# **HORNSEA PROJECT ONE – NAME PLATE CAPACITY AND LIMIT OF DEVIATION WORK AREA DCO AMENDMENTS SUPPORTING STATEMENT**

Doc. no. 2463966  
Ver. no. 2463966A  
Case no. 200-12-2161

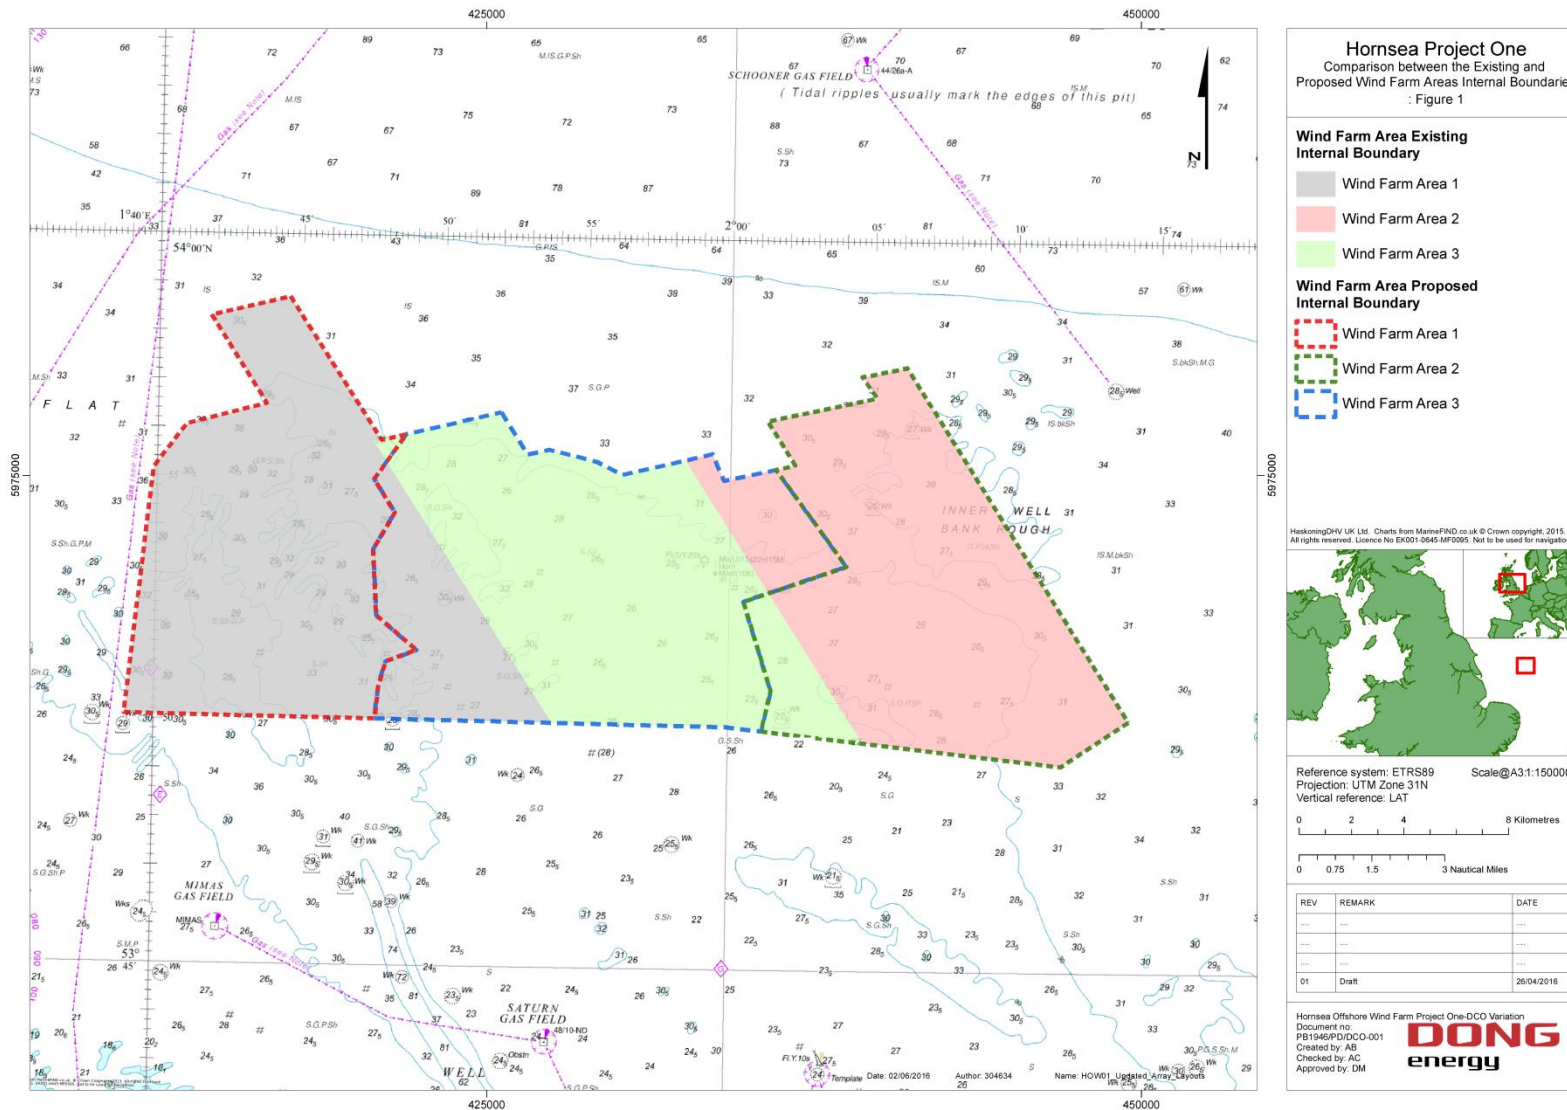
The consented and proposed limits of deviation are given in **Appendix A. Figure 1** illustrates the existing consented and proposed amendments to Wind Farm Areas 1, 2 and 3 boundaries.

**Table 3.3** below shows the relative sea areas in km<sup>2</sup> between the Wind Farm Areas under the existing and proposed coordinates.
